# **Mobile Intel® Celeron® Processor at 466 MHz, 433 MHz, 400 MHz, 366 MHz, 333 MHz, 300 MHz, and 266 MHz Specification Update**

Release Date: April 2002

Order Number: 244444-031

**Figure 1. An Example of Microcontroller Driven Thermal Management**

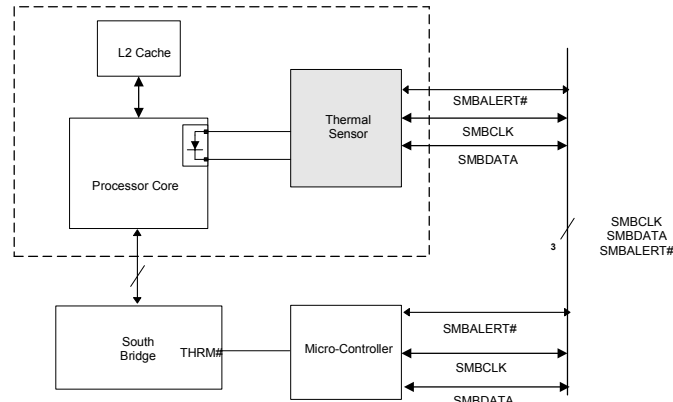
## H29. Thermal Sensor May Assert SMBALERT# Incorrectly

**Problem:** The Intel Celeron Processor Mobile Module has a thermal sensor that monitors the processor core's temperature. Please note that desktop systems could have a similar thermal device. The thermal sensor asserts SMBALERT# if the processor temperature exceeds the temperature limits set in the Alarm Threshold Registers ( $T_{HIGH}$ ,  $T_{LOW}$ ). It also sets the corresponding Status Register bits to identify the cause of the interrupt. Figure 1 gives one example of the how the SMBALERT# signal could be used in a system.

**Implication:** There is no system impact from this erratum if temperature polling is used for processor thermal management. If the SMBALERT# interrupt is employed to manage processor thermal sensing, then servicing the false interrupt may result in premature system action depending on the software and hardware implementations used. The rate of the false interrupts is less than the auto-convert rate of the thermal sensor.

**Workaround:** Three different (mutually exclusive) workarounds are possible:

1. Before servicing an interrupt from the thermal sensor, read and compare the processor thermal reading with the threshold limits ( $T_{HIGH}$  or  $T_{LOW}$ ). Figures 2 and 3 provide basic flowcharts for the implementation of this workaround in an interrupt driven system.
2. If the firmware implemented polls the Status Register only, then before taking any action, re-read the temperature register and do a comparison with the alarm threshold limits ( $T_{HIGH}$  or  $T_{LOW}$ ) to determine if the value is actually still within the temperature window.
3. Use a temperature polling scheme to monitor the processor temperature.
